**EXH. JPH-4  
DOCKETS UE-240004/UG-240005  
2024 PSE GENERAL RATE CASE  
WITNESS: JAMES P. HOGAN**

**THIRD EXHIBIT (NONCONFIDENTIAL) TO THE  
PREFILED DIRECT TESTIMONY OF**

**BAKER RIVER PROJECT**  
**Board of Consultants Report for Meeting No. 6**  
**Puget Sound Energy Conference Center, Snoqualmie, WA**  
**12 - 14 December 2017**

Figure 1 Potential Leakage Path

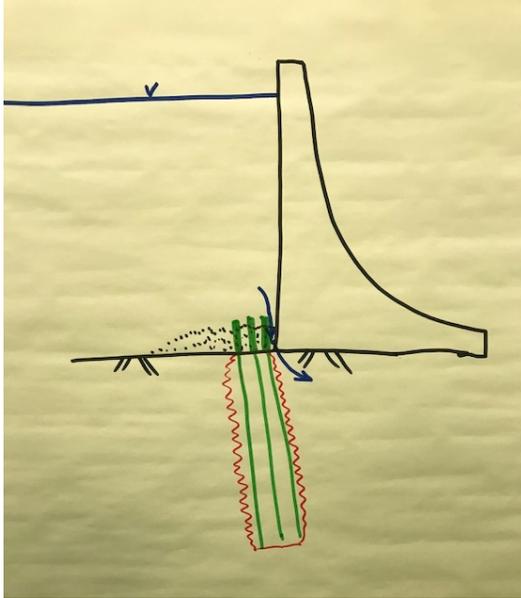
- a) Yes. Our only concern would relate to the possibility that the materials placed would in some way prove a challenge to the drilling activities for the grout curtain or the efficiency of the horizontal seal between the grout curtain and face of the dam. See Figure 1 for a sketch of a potential leakage path.
- b) Yes. Any intervention to reduce the velocity of the seepage prior to and during grouting will increase the likelihood of successfully constructing the curtain to satisfy design requirements (i.e. residual permeability of the grouted mass).
